January 16, 2014

**Re: Henderson Development, Permit No. M-1980-110 (Sandy Acres Pit)**  
**Technical Revision Application No. TR-02**

NOME STREET PAVING DETAILS

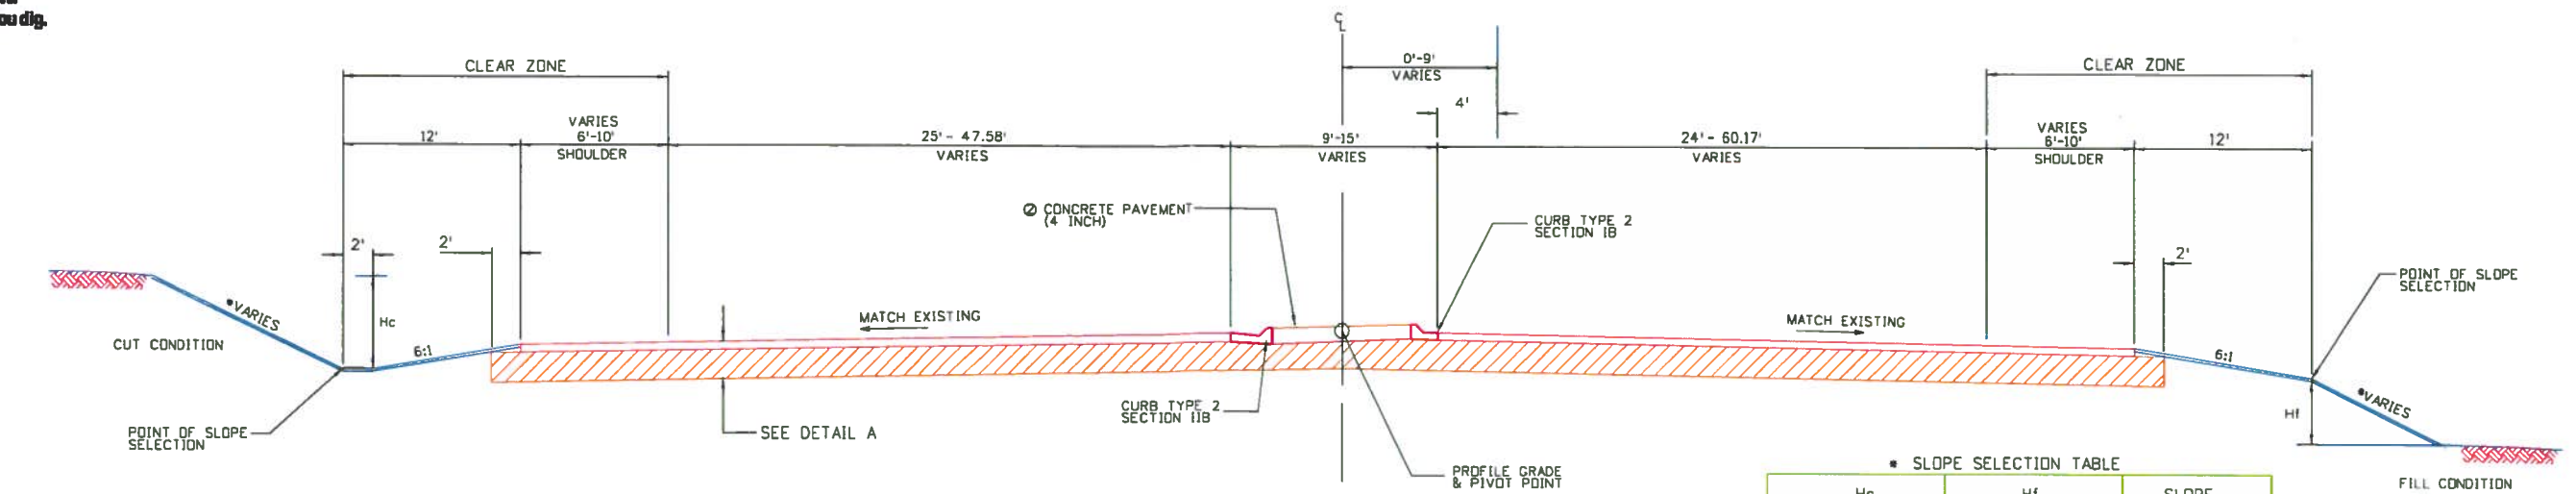
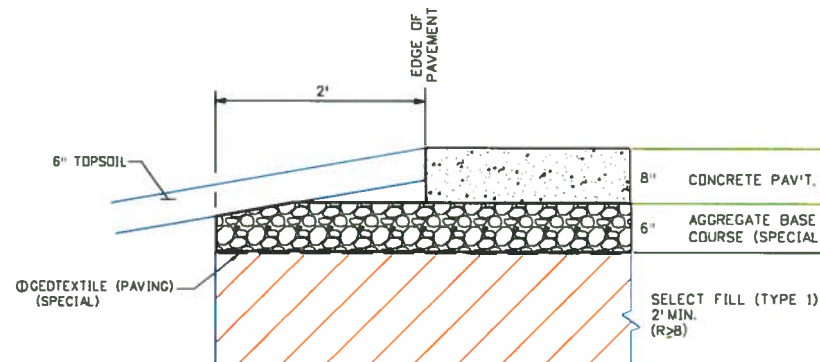
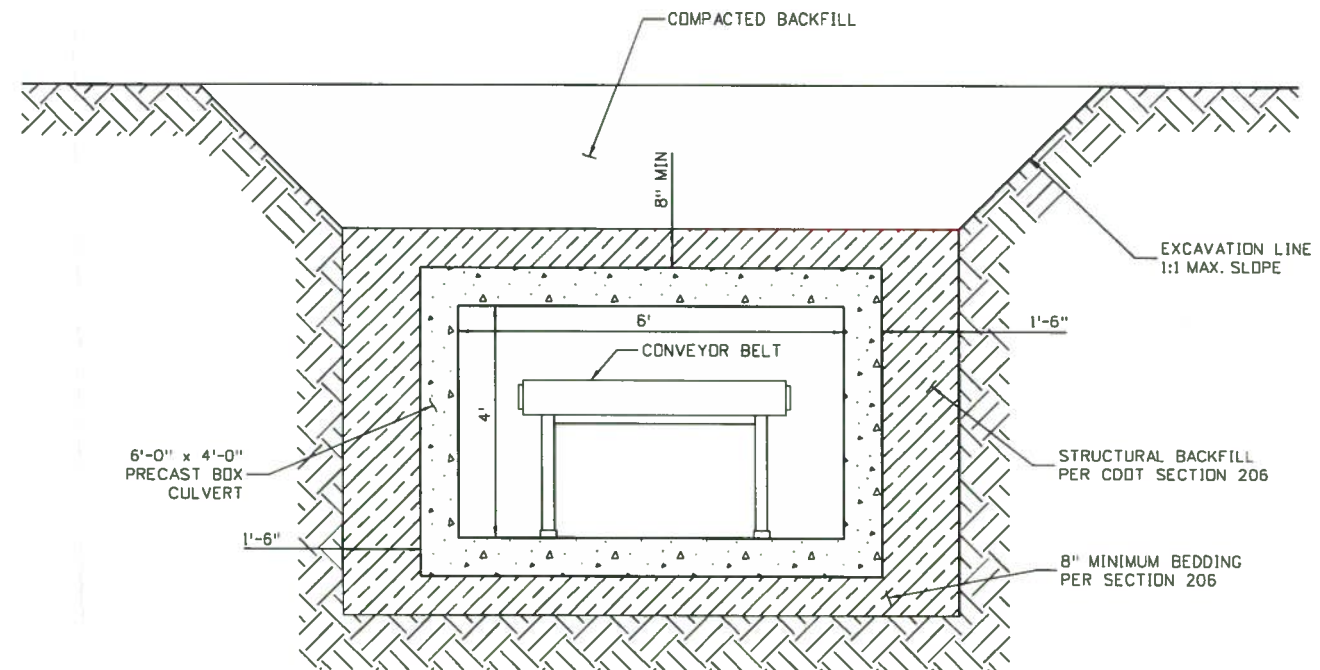
7. **Exhibit F, Reclamation Plan Map.** Please see attached plan sheet 5, a revised reclamation map, which shows the conveyor system (inside the box culvert) crossing below the access ramp. I have also enclosed plan sheets 3 and 4 which show the box culvert details.
